UNITED STATES ENVIRONMENTAL PROTECTION AGENCY
REGION IX
75 Hawthorne Street
San Francisco, CA 94105-3901

February 5, 2021

Re: Technical Evaluation Comments and Information Request of CES's Responses to EPA's Initial Technical Evaluation Comments and Information Requests #1-4
CES-Mendota Site Underground Injection Control (UIC) Permit Application
Class VI Pre-Construction Permit Application No. R9UIC-CA6-FY20-1

Evaluation of Applicant Responses to EPA's Technical Review Comments on the Geologic Information in the CES-Mendota Class VI Permit Application

Figure 2a and 2b: San Joaquin basin depositional model showing three possible depositional scenarios for the location of Mendota_INJ_1. Modified from (Hosford Scheirer & Magoon, 2007)

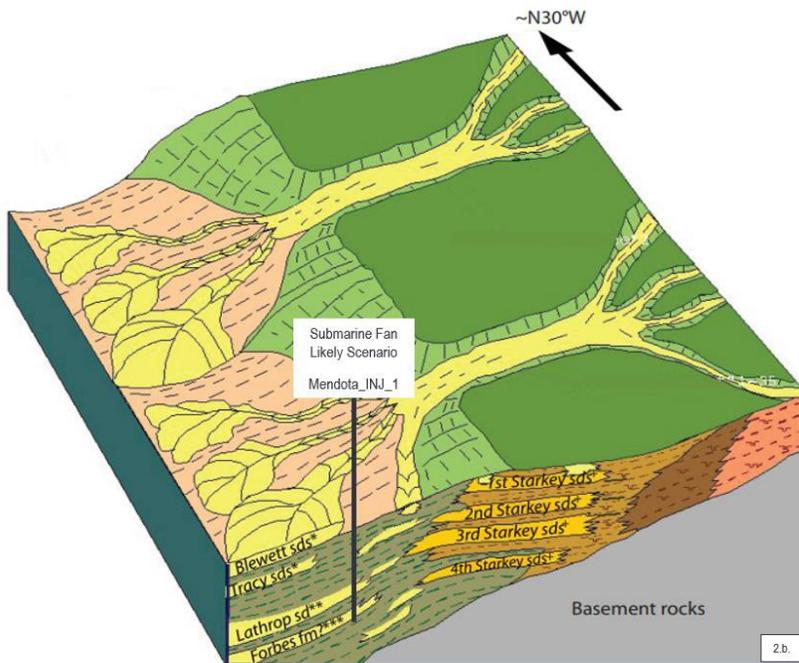
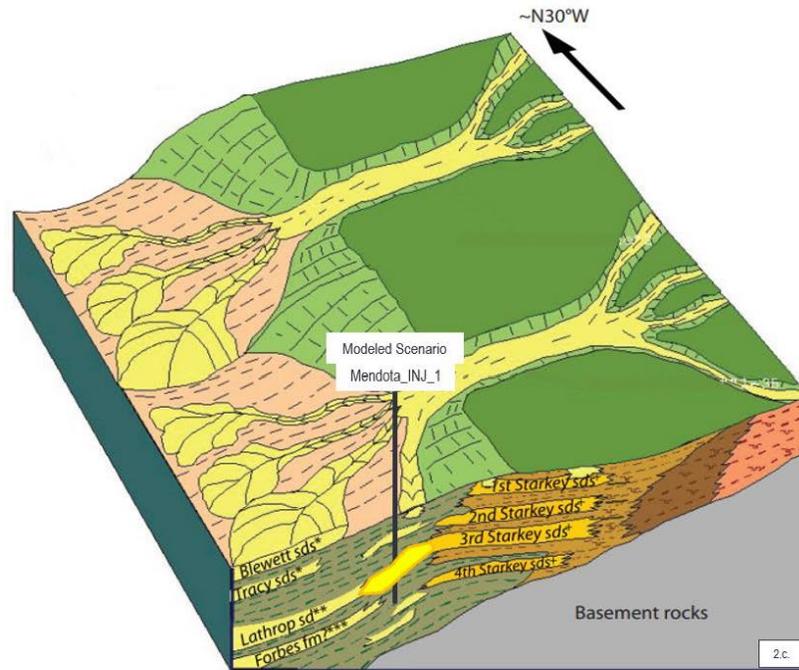
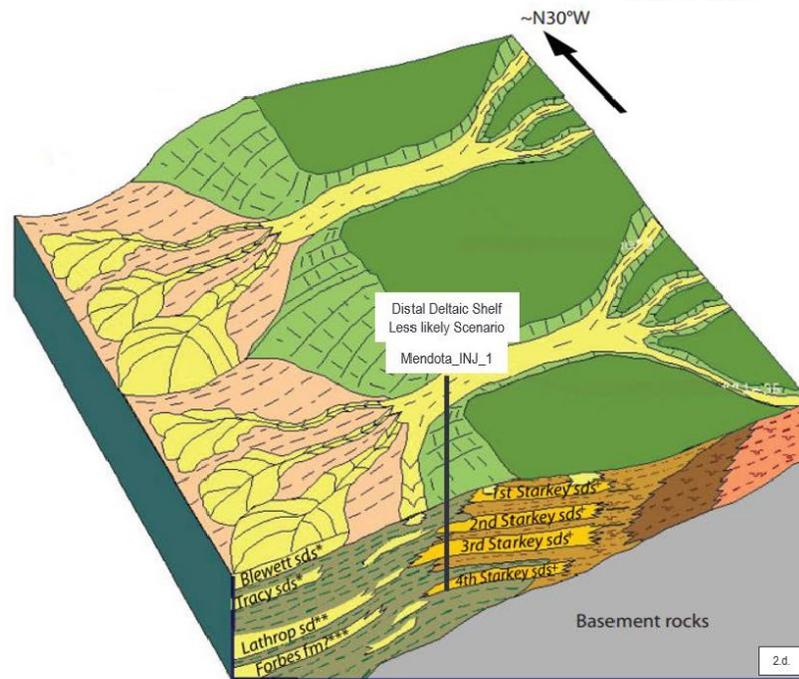
- Regarding the locations of the Mendota INJ_1 well in Figures 2a – 2d, are they supposed to be the same? They appear to be in slightly different locations within the block diagram. Is this intended to simply represent uncertainty in where the sands pinch out?
- Is the 2nd Starkey the same as the 2nd Panoche? If so, then is it coeval with the Tracy sands? The diagram in Figure 2c (modeled scenario) shows the well penetrating the level of the 3rd Starkey. In the “likely scenario” in Figure 2b, it appears that the well goes as far down as the level of what might be the 4th Panoche sand. Although the 3rd and 4th Panoche sands are potential injection scenarios, should the diagrams in Figures 2a-2d represent the planned injection into the second Panoche?

Figure 5: Porosity-permeability crossplots of well logs vs. facies type (sand and shale) (from Petrel 2019).

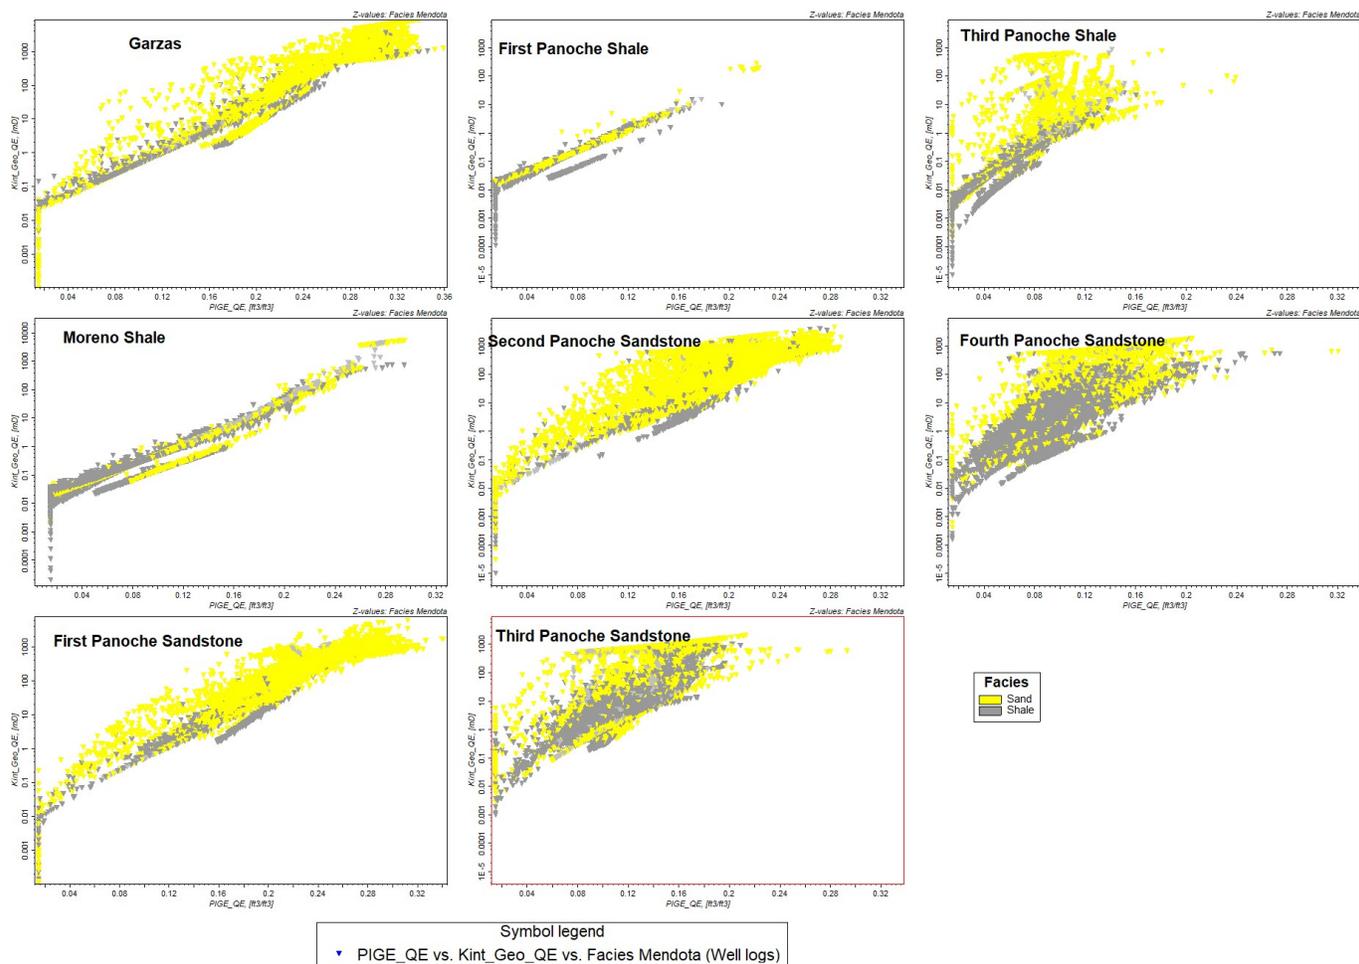
- Please clarify the meaning of the zones in the legend of Figure 30. Are they equivalent to the formations, as suggested by the legend?
 - *Zones are equivalent to formations. For clarity, Figure 30 has been updated and divided into Figure 3, Figure 4, and Figure 5 in Appendix A.*

In comparing Figure 1 in the Rock Type file with Figure 30 of the narrative, the facies in Figure 30 show a broad spread rather than the sharp dividing line in Figure 1. It appears that a number of shale data points in Figure 30 were assigned to the sandstone facies by the neural network training method in Figure 1. There also appears to be a significant difference in porosity between the Fourth Panoche and the Second Panoche Sands in Figure 30.

Figure 6. Rock types along the E-W cross section (from Petrel 2019).

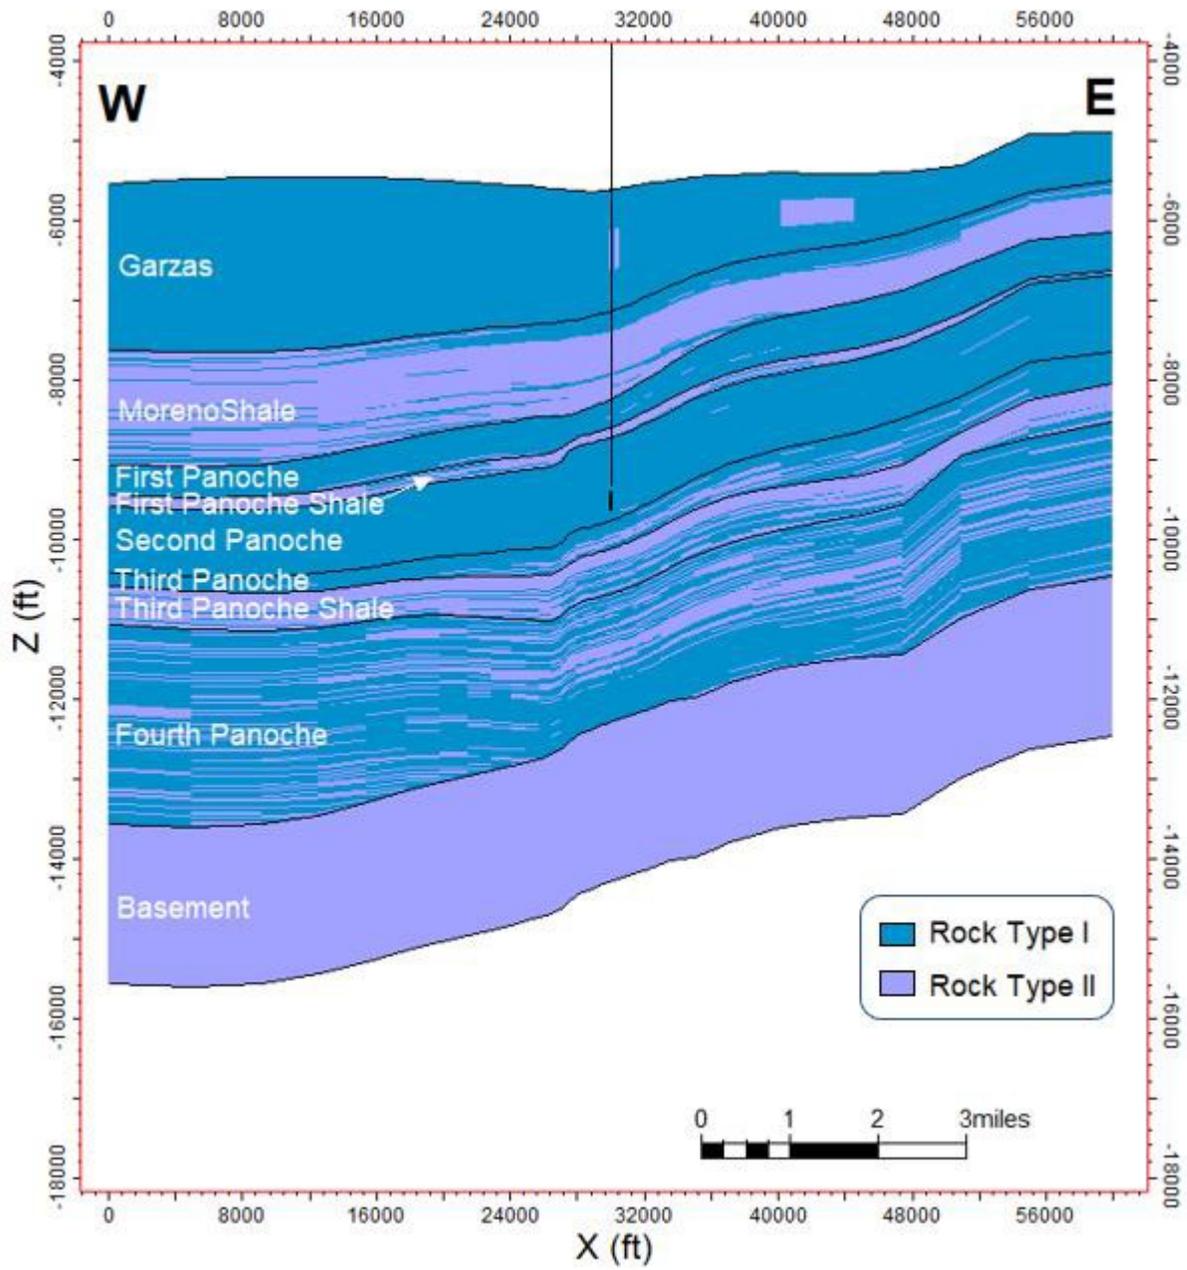
- Is there a difference between the two shades of blue in Figure 2 of the Rock Types file?
 - *No, the different blue shades are due to the presence of grid lines shown on the figure. Refer to Figure 6 in Appendix A for an updated version.*

- Please label the formations in Figure 2.
 - *Refer to Figure 6 for an updated version of Figure 2 in Appendix A which includes the formation names.*

Figure 7. Upscaled porosity profile along the N-S cross-section.

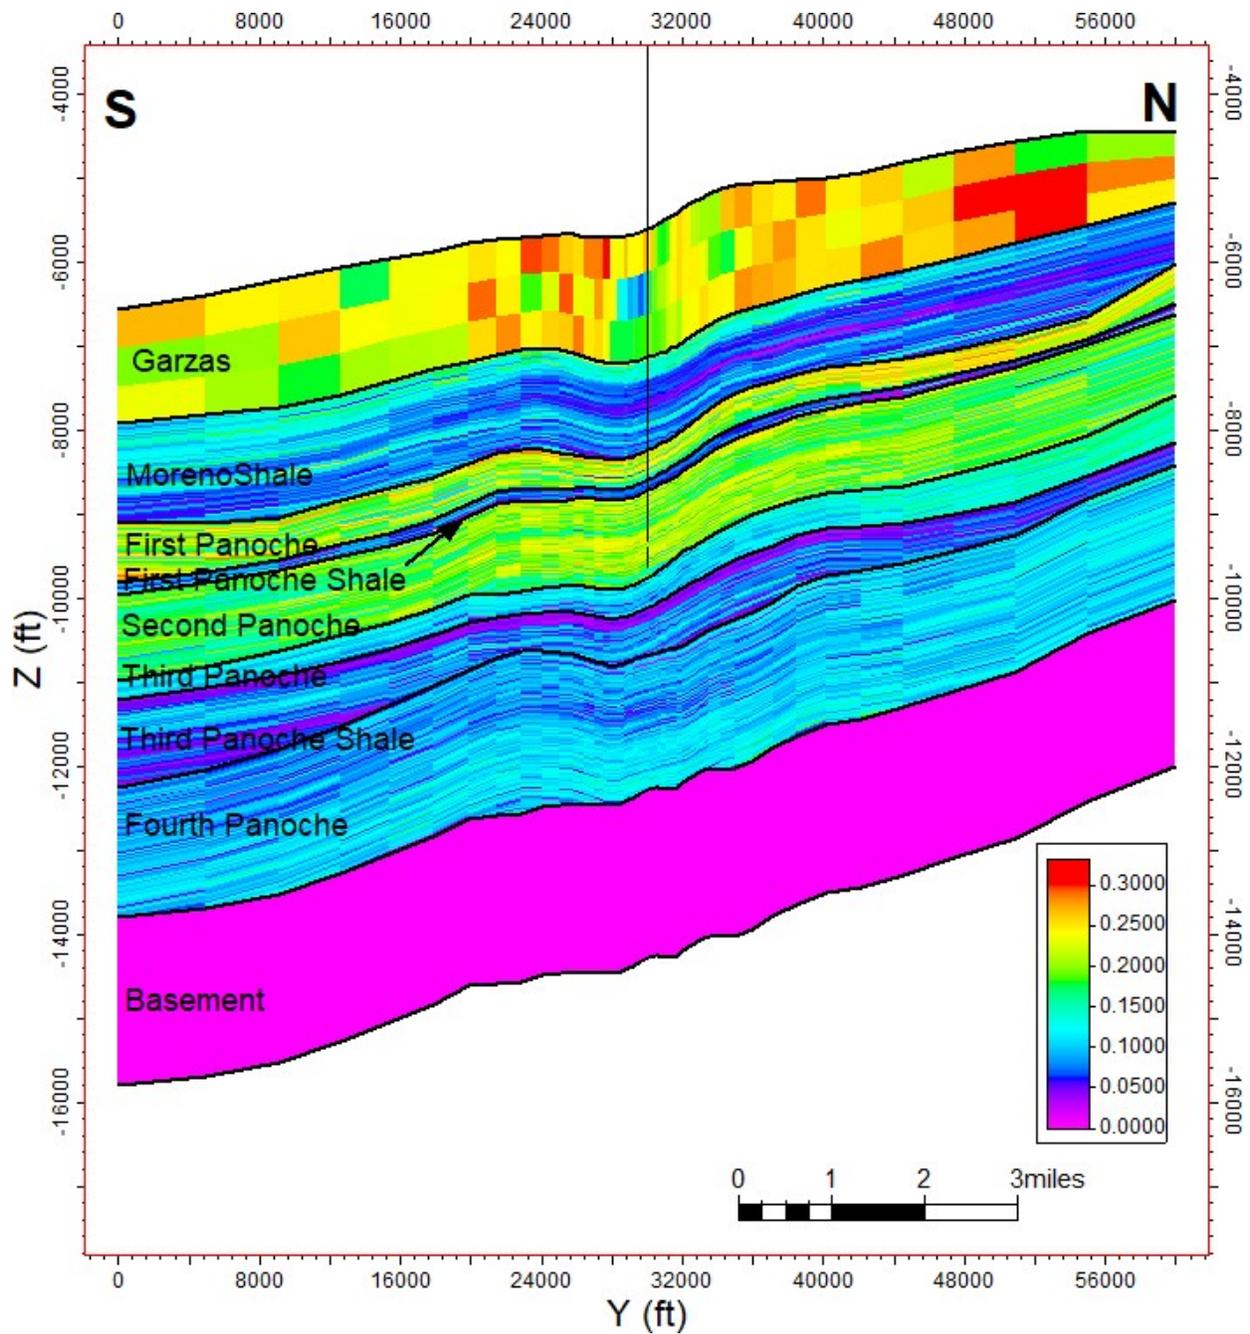
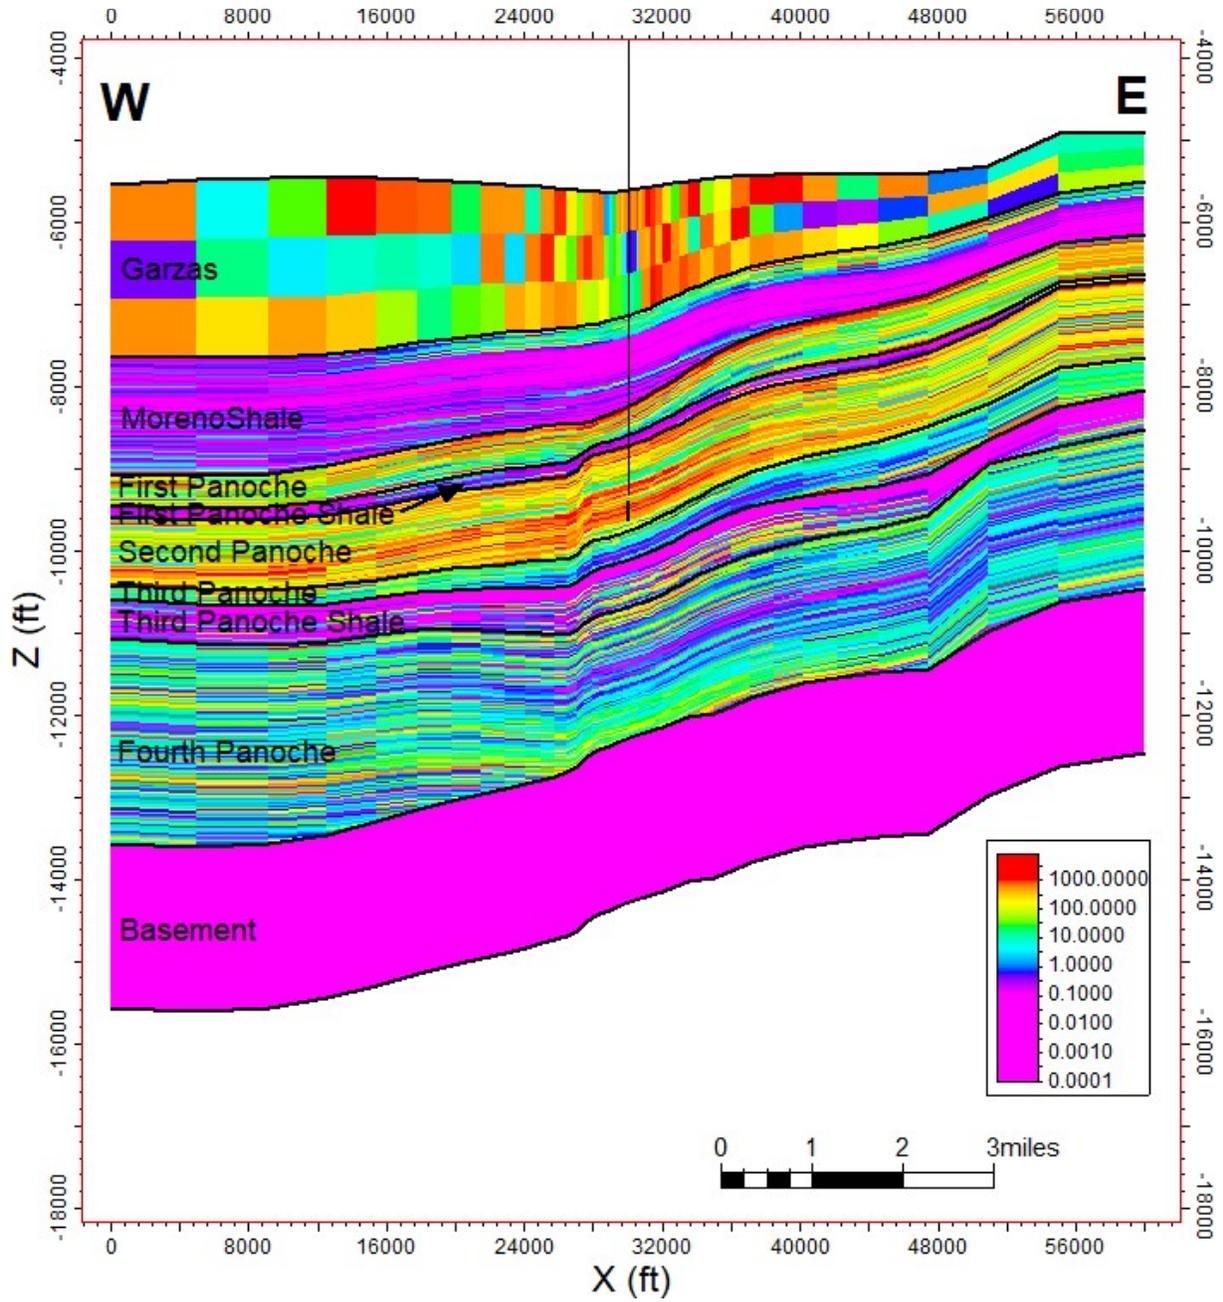
2.3.1	“The upscaled porosity and permeability graphics in Attachment B (Figures 3 and 4) would benefit from labeling for formation tops.”	<i>The figures were updated with formation tops in Figure 7 and Figure 8 (refer to Appendix A).</i>

Figure 14: BB Co. 1 wellbore after P&A operation

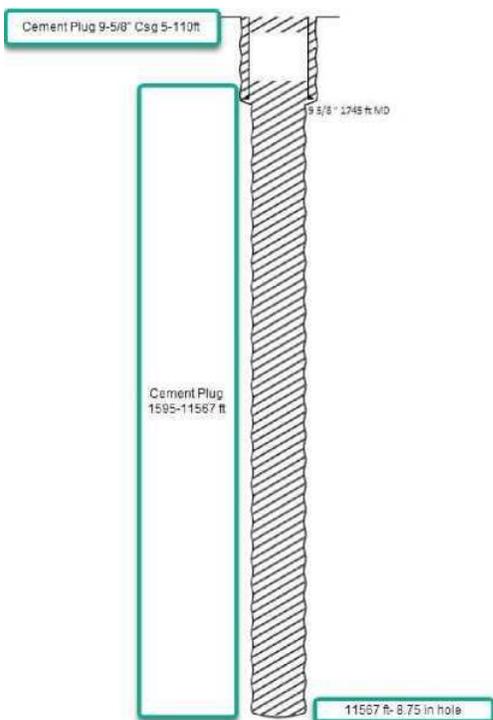
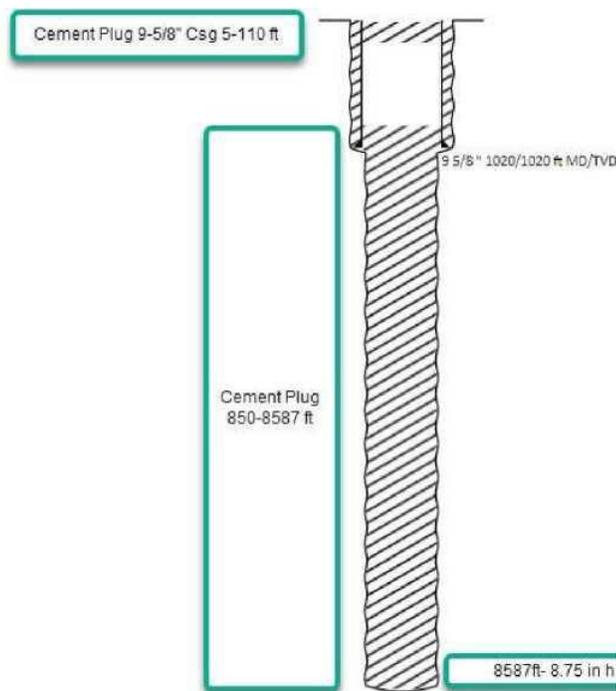
- *The plugging procedures for Amstar 1 and BB Co 1 on pages 25 and 26 reference a casing diameter of 9 5/8 inches; however, figures 14 and 15 show that the hole is 8.75 inches. Please clarify the discrepancy.*
- *This is correct. The 9 5/8-in. surface casing has drift inner diameter of 8.75 in. Therefore, an 8.75-in. hole was drilled below the 9 5/8-in. casing.*

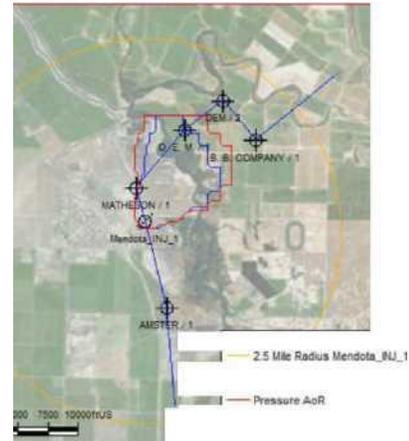
The map of monitoring well locations can be compared to the expected extent of the plume after 20 years, as shown on the map to the right of the figure above (from Figure 12 of Attachment B). While the scales of the maps in the plans are different, they have the same legend and it appears that the monitoring wells will be located within the defined AoR and in the anticipated direction of plume and pressure front movement. The suitability of these proposed locations will be refined as the AoR modeling evaluation proceeds.

- *Please provide a map that shows the location of the monitoring wells at a scale that also shows the extent of the plume and pressure front (i.e., Figure 12 of Attachment B and Figure 1 of Attachment C at the same scale)*
- *Please refer to Figure 4-1 in Appendix A in this document, which is the replacement map combining maps from Figure 12 Attachment B and Figure 1 Attachment C.*
